Safety Evaluation Report

Renewal of the Facility Operating License for the Purdue University Research Reactor, PUR-1

License No. R-87
Docket No. 50-182

U.S. Nuclear Regulatory Commission

Figure 4-1: PURDUE University Training Reactor - TRACE Model

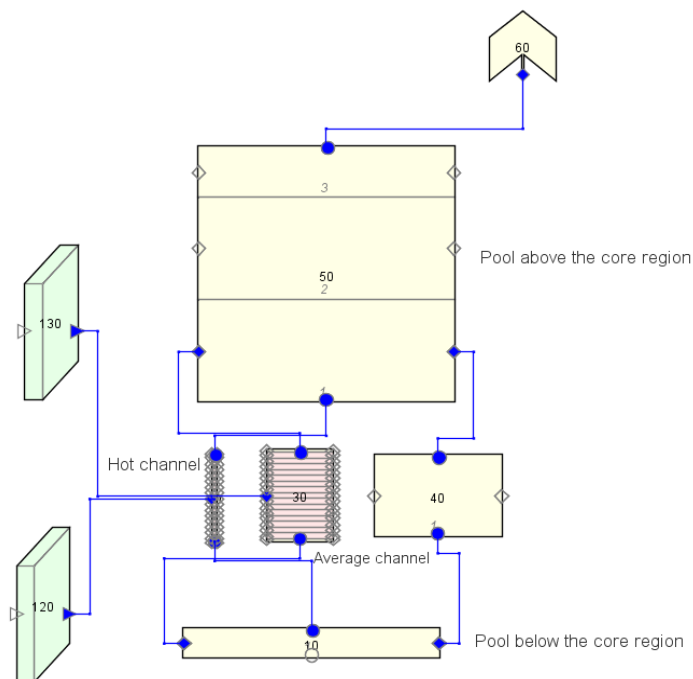
The NRC staff performed confirmatory calculations to verify the magnitude of the ONB conditions using the TRACE computer code (Ref. 37). These results demonstrate that at the analyzed operating power conditions of 1 kWt and 12 kWt large margins exist to the core power corresponding to the onset of nucleate boiling. Additionally, large temperature margins exist to the incipient boiling and the fuel safety limit of 530 °C (986 °F). The model used by the NRC staff is displayed in Figure 4-1.

The NRC's TRACE model predicts a lower coolant velocity resulting in a slightly higher exit coolant temperature. The maximum fuel temperatures as calculated by TRACE are somewhat lower than in the NATCON model due to differences in the fuel heat conduction model. The predicted maximum fuel and clad temperatures are much lower than the blister temperature of 550 °C (1022 °F). TRACE doesn't have the capability to evaluate the NATCON calculated margin to incipient boiling, which is 68.1 °C (155 °F) at 18 kWt.

Figure 4.2: Peak Cladding vs. Saturation Temperature

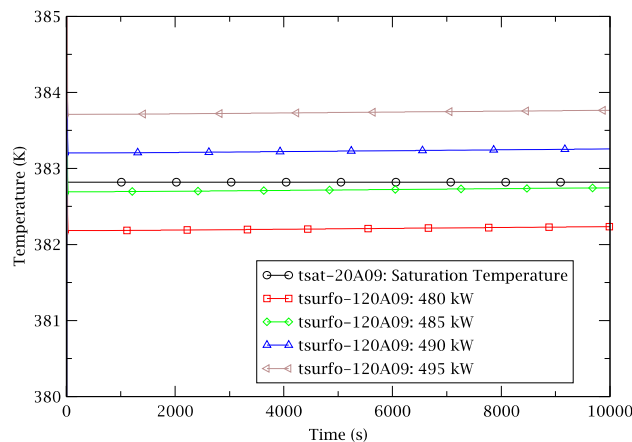
The ONB conditions are simulated by TRACE by increasing the peak plate power until the peak cladding temperature equals the fluid saturation temperature corresponding to the onset of boiling. Figure 4.2 compares the peak cladding temperature at different reactor core powers with the fluid saturation temperature. The results indicate that the ONB does not occur in the hot channel with the total power level of up to 485 kWt.
